AMENDMENT NO. 53 TO THE OFFICIAL PLAN

135, 139, 147, 153 and 161 Jackson Avenue and 136 Brentwood Avenue

To:	Brian Bateman, Senior Planner
From:	Juliane vonWesterholt and Trevor Hawkins, MHBC Planning
Date:	April 26 th , 2024
Our File:	22184 A
Subject:	135-161 Jackson Ave. and 136 Brentwood Ave. OPA and ZBA applications

**RE: 135-161 JACKSON AVENUE AND 136 BRENTWOOD AVENUE, KITCHENER
EMERGENCY ACCESS ON BRENTWOOD AVENUE**

Fire Route Analysis

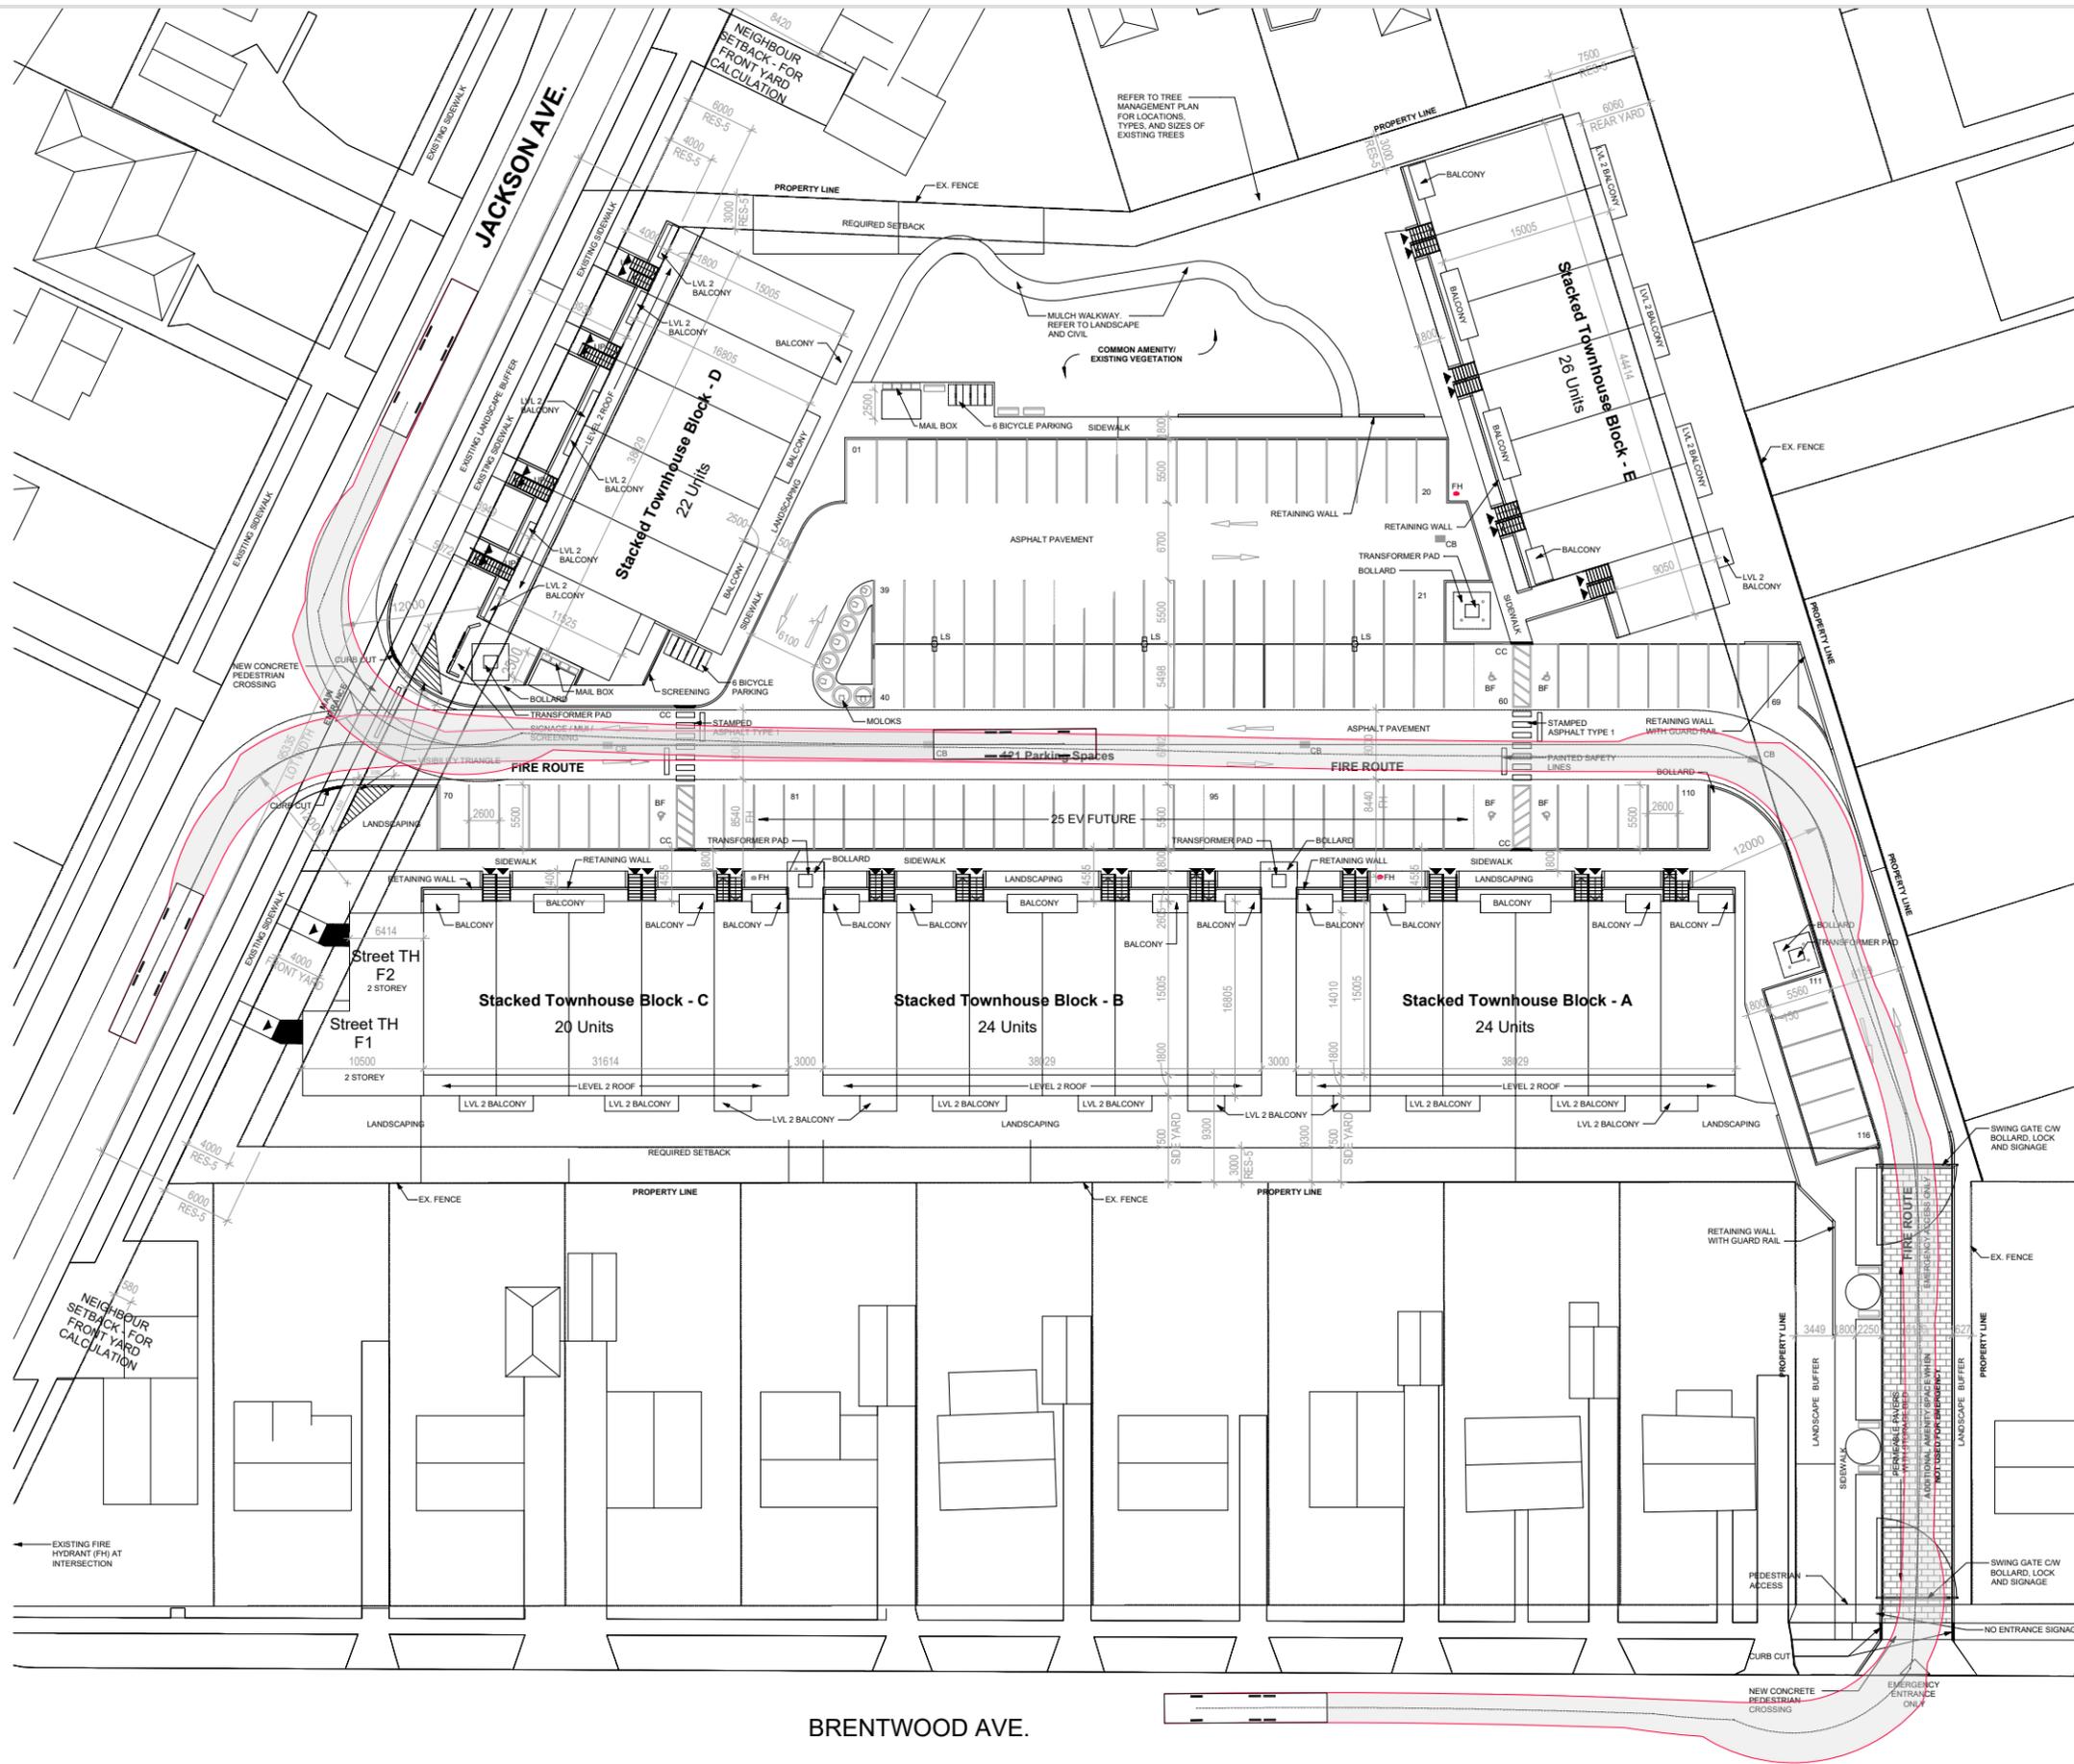
A truck turning analysis was completed and confirmed that a fire truck could safely enter and exit the site. In addition, the Paradigm Transportation Solutions Inc. confirmed that the single access onto Jackson Ave. can accommodate the traffic generated by this site (see attached Appendix A).
